UPPER TRISHULI-1 HEP (216MW)

REVIEW NOTE

| Title of the Document | Excavation and Initial Support Drawings of Adit No. 3 | | |
| Review Note No. | RN-0054 | Present Review Date | 04.02.2022 |

Drawing UT1-C-150-CVL-DG-43004-01, Rev. 0

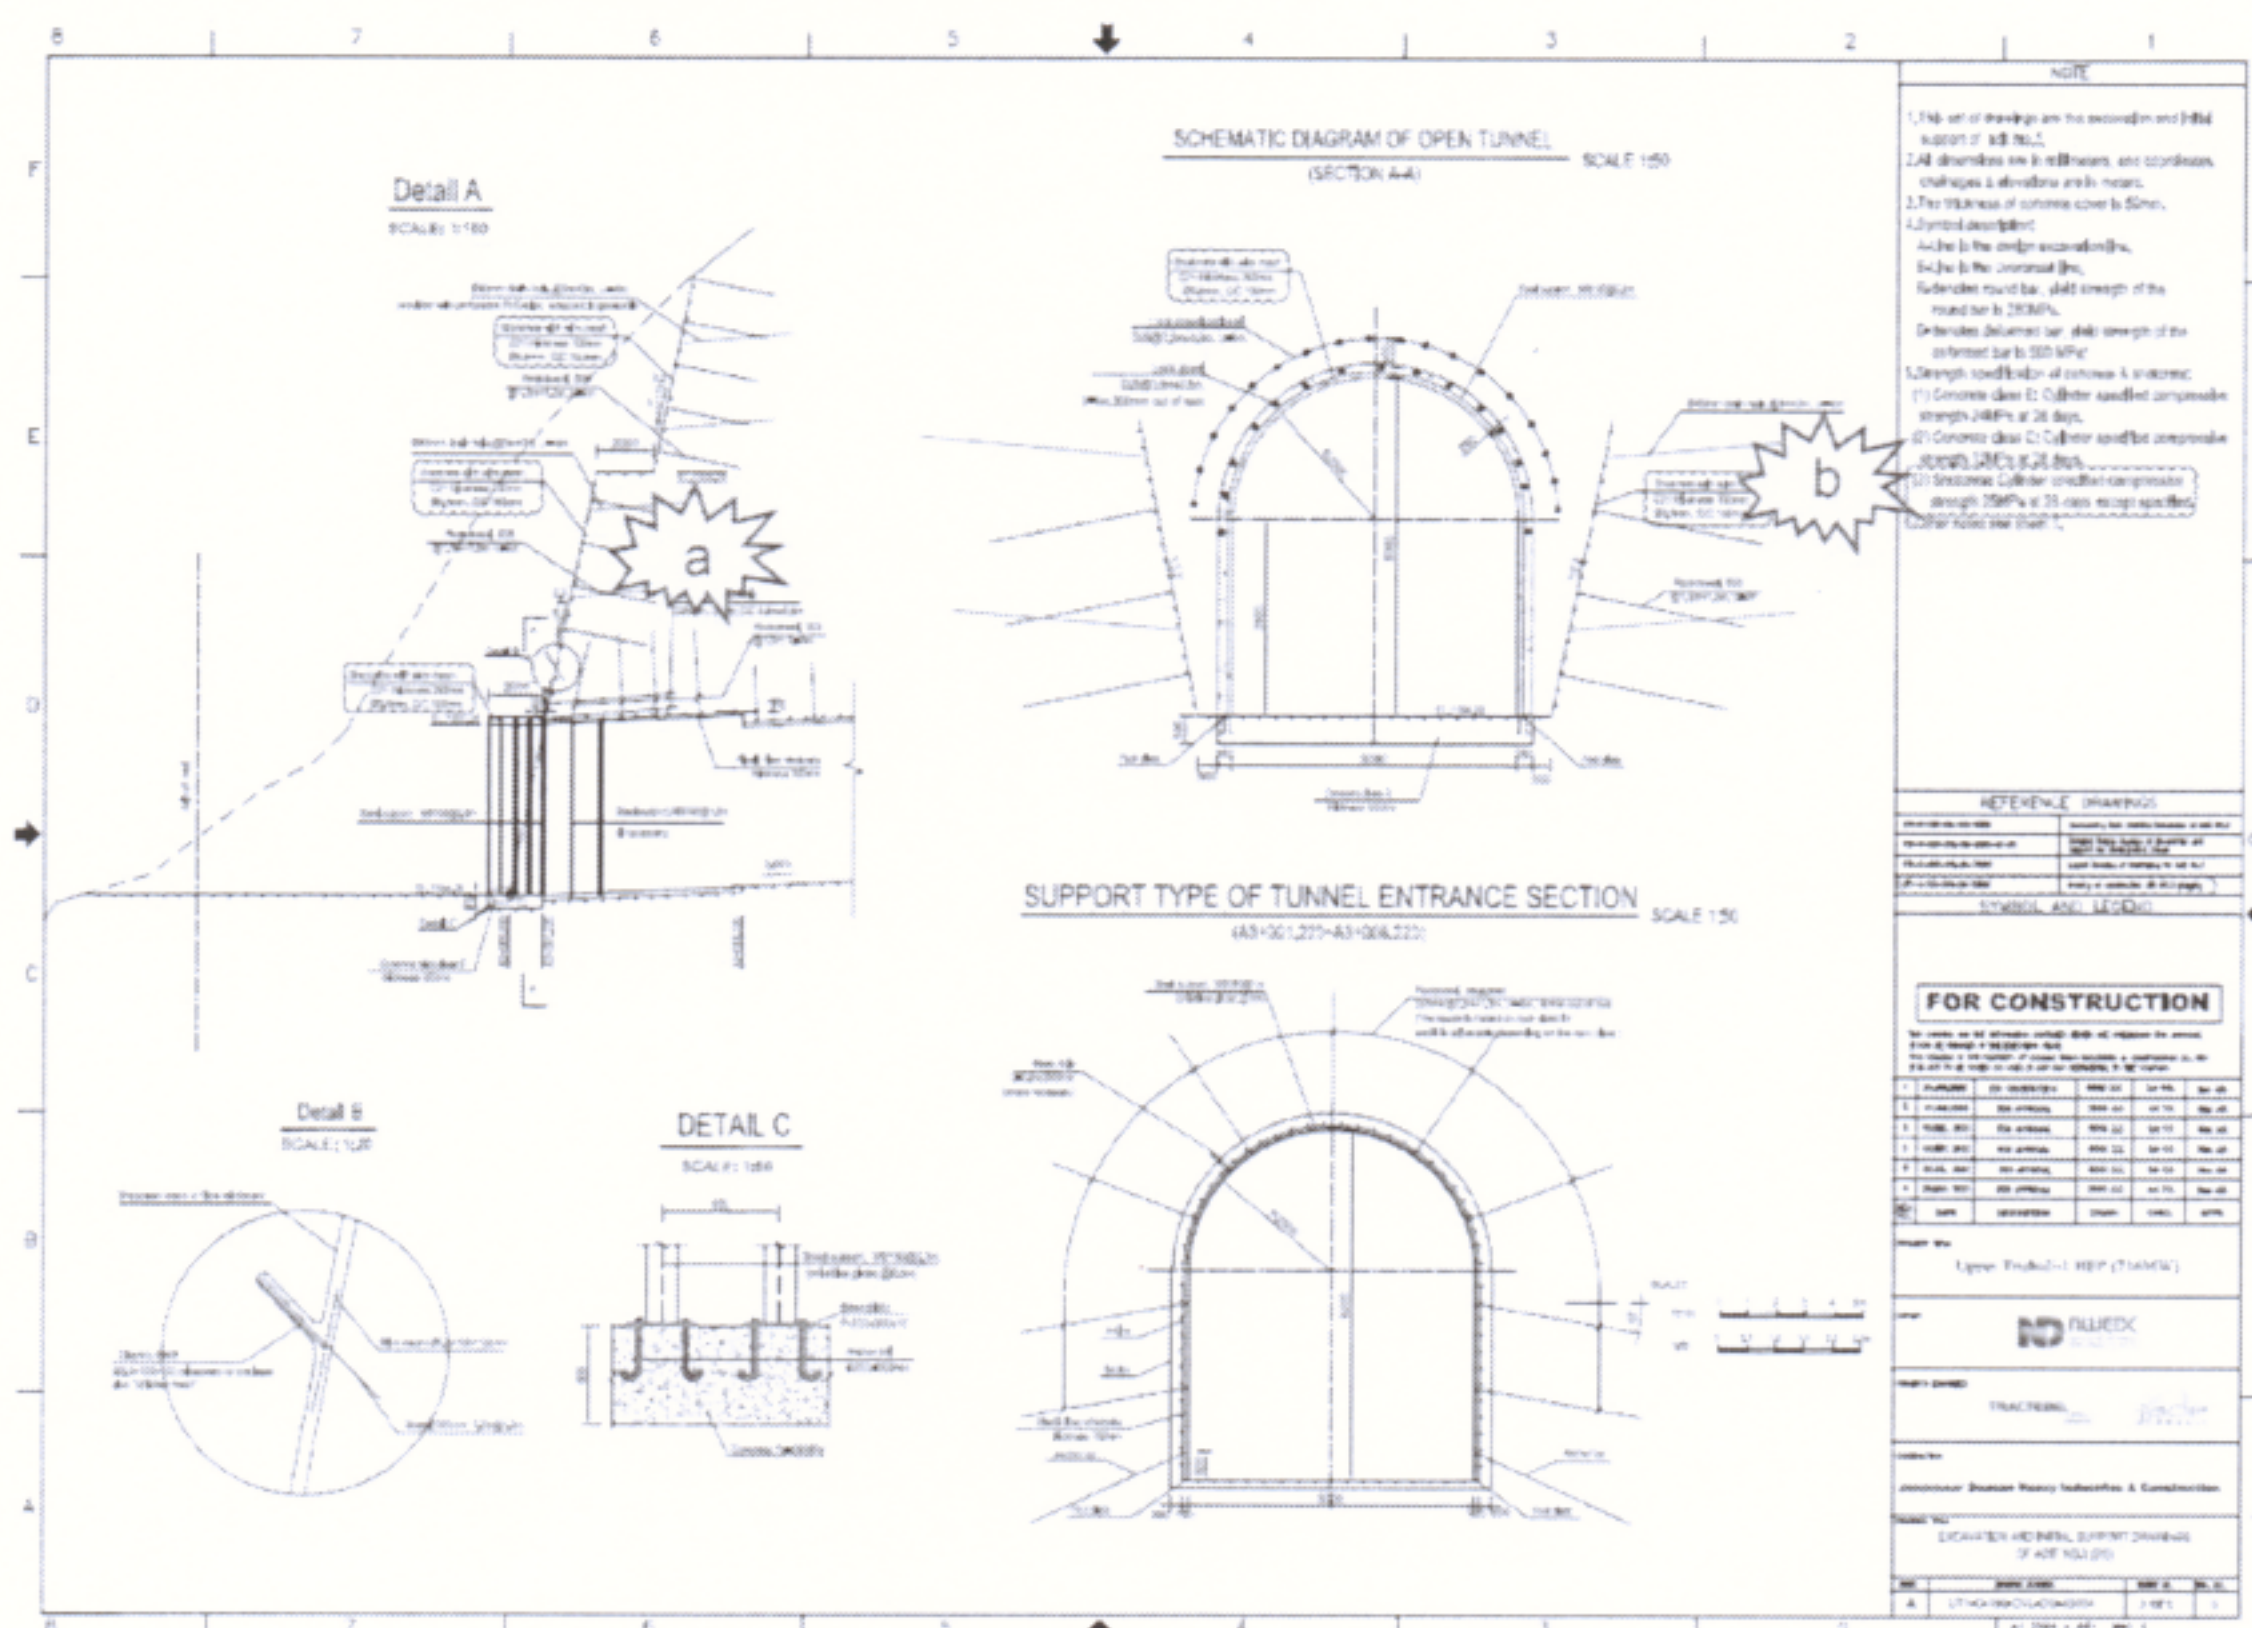
a) **Add** to the sentence “This drawing... ..in the execution stage, **with written approval of the OE.**”

Drawing UT1-C-150-CVL-DG-43004-02, Rev. 0

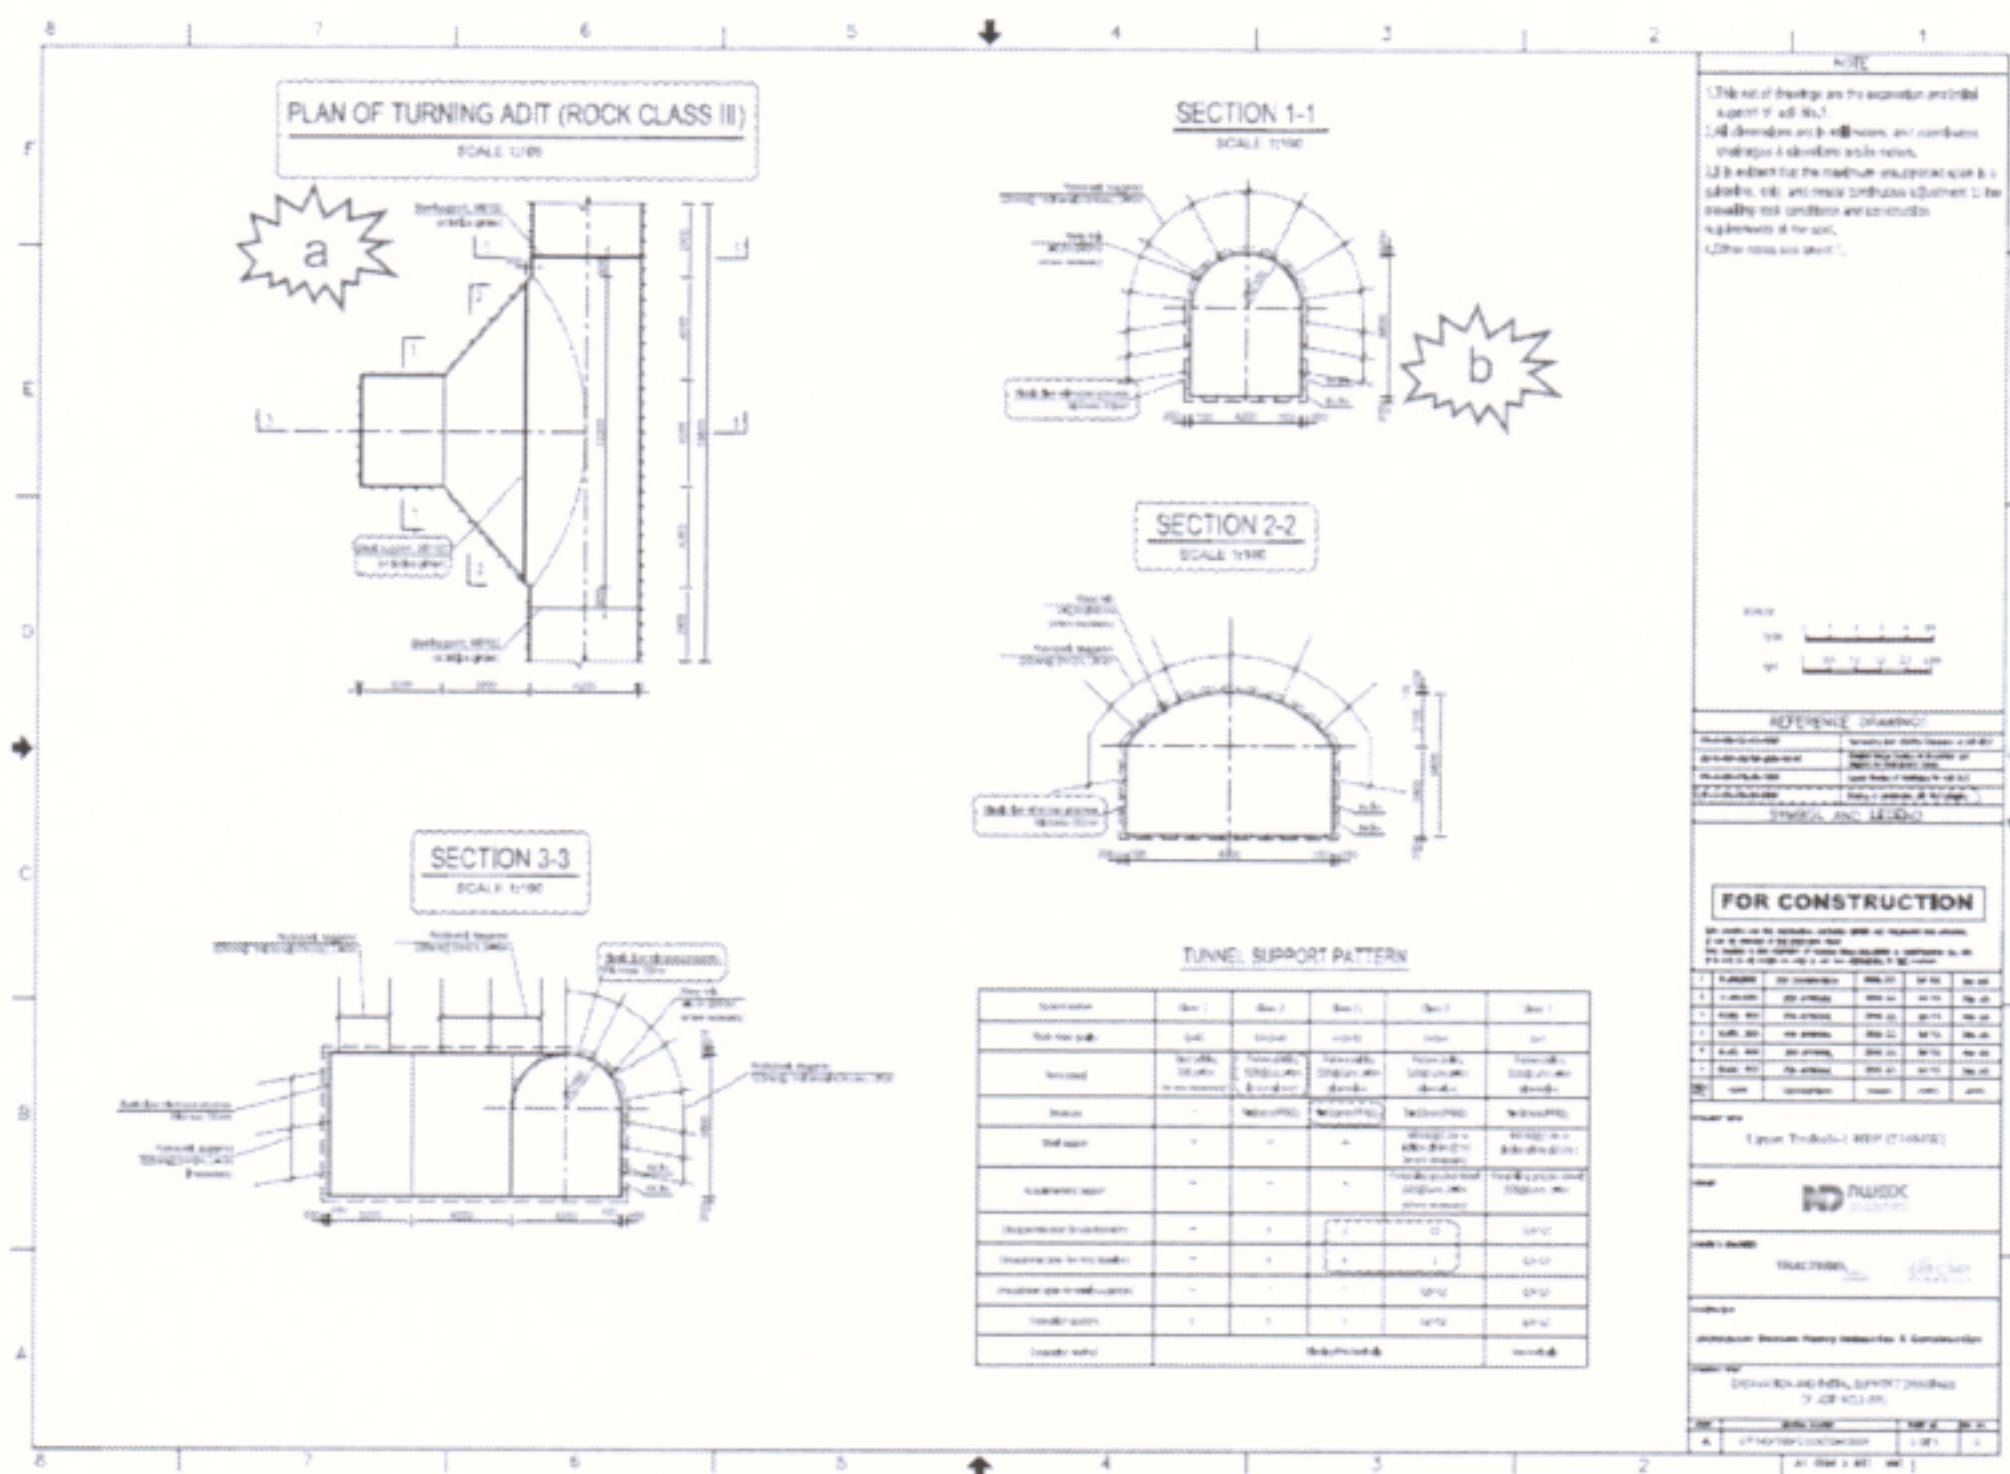
- Replace the 3 m long drain holes with weep holes (for rock slopes).
- Provide a note that refers to the early strength requirements as per contract.

Drawing UT1-C-150-CVL-DG-43004-03, Rev. 0

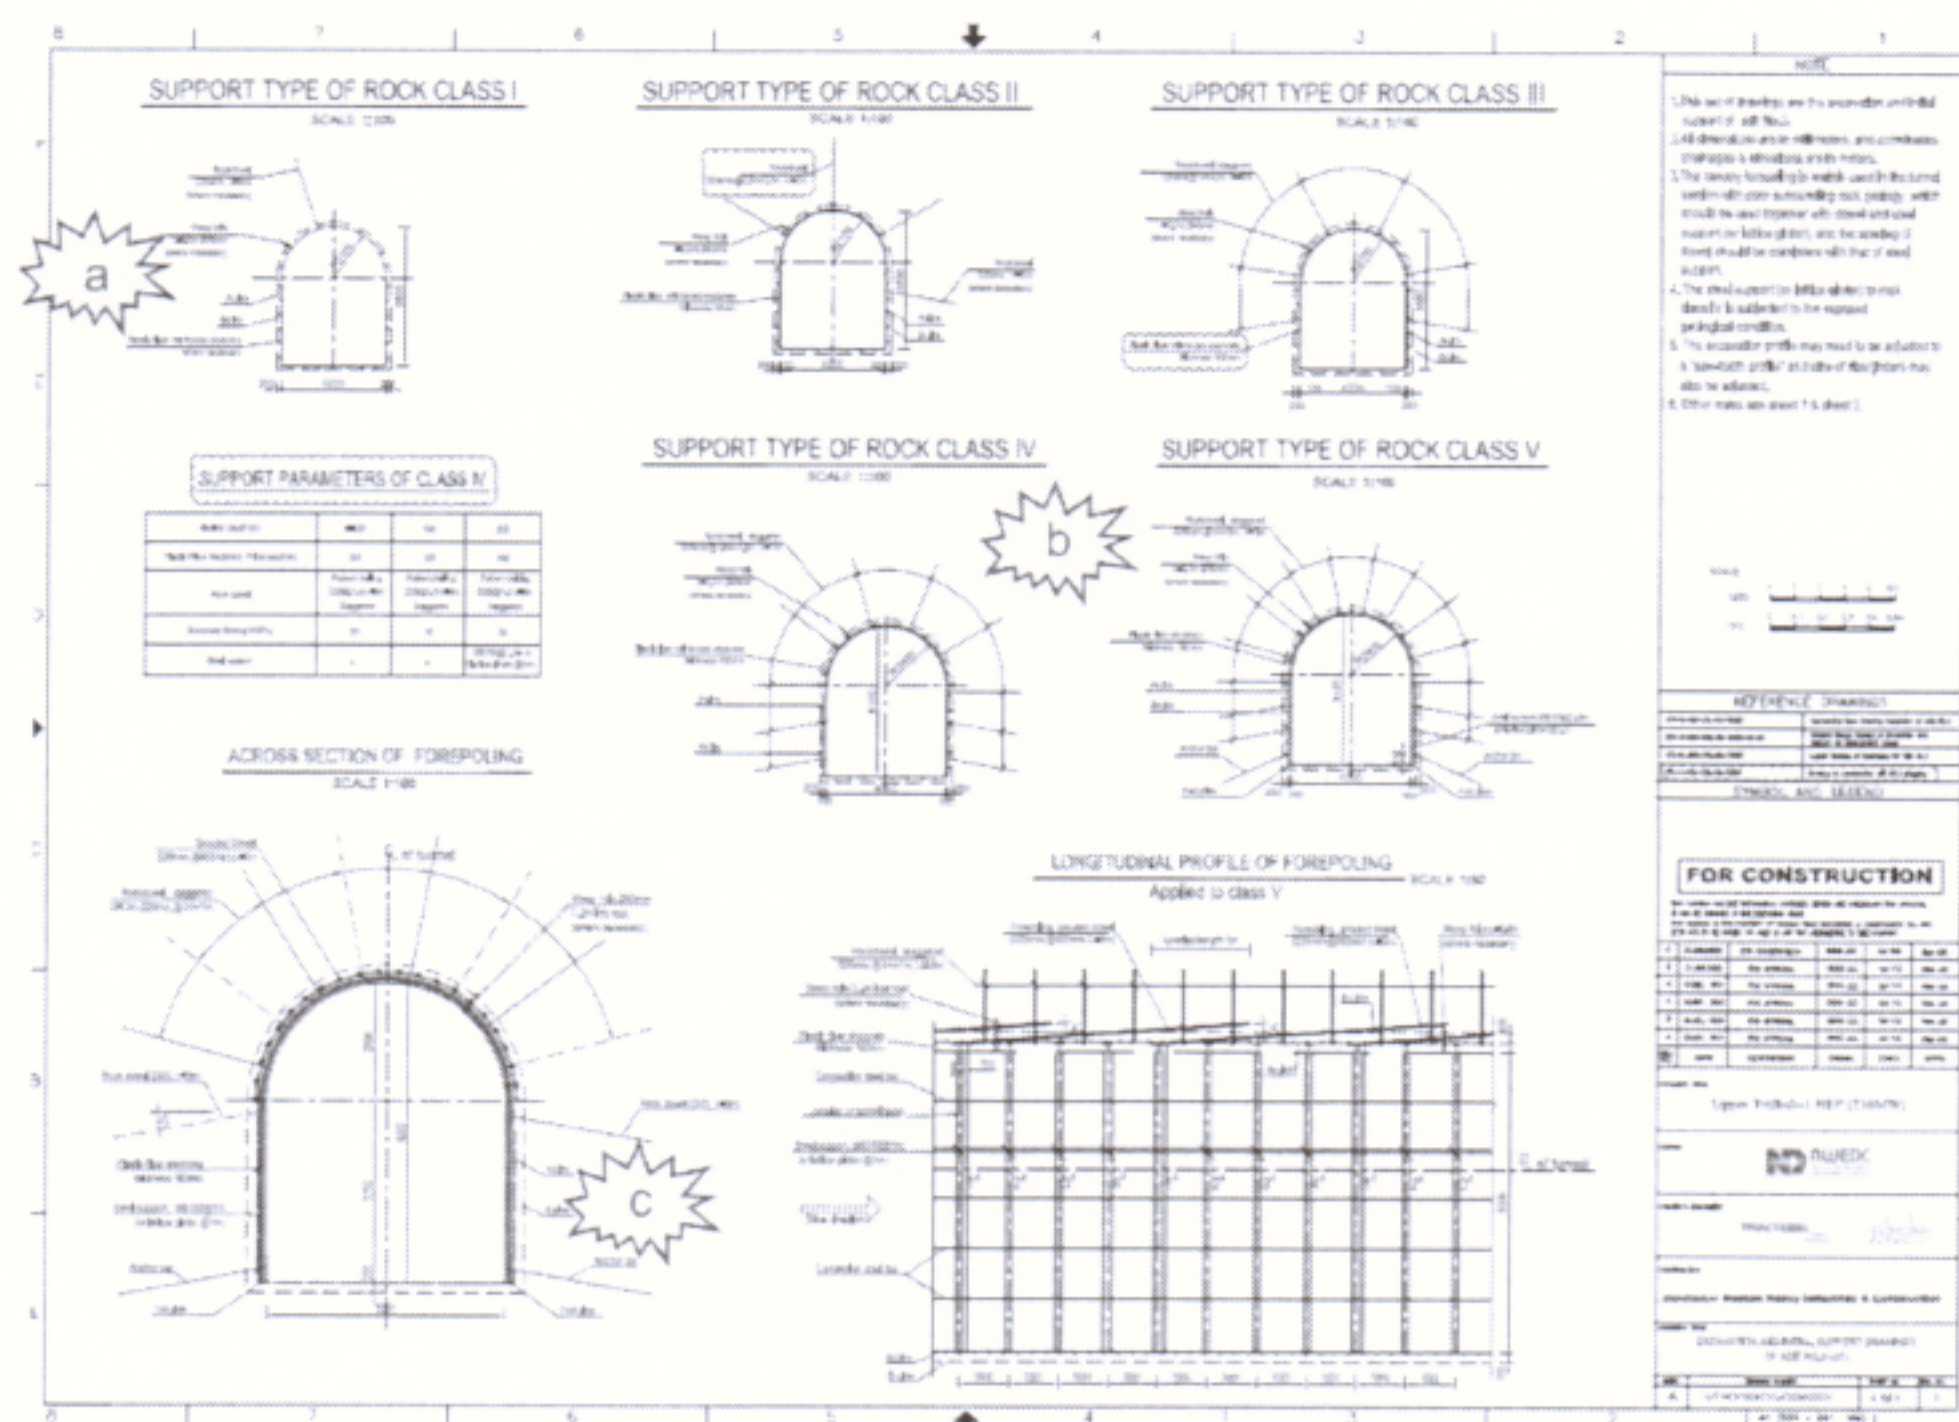
- a) Note that the steel ribs at the start and end of the turning bay are only required in Class III, IV and V.
- b) For Class III in sidewalls no rock dowels below 1.5 m required. Revise.
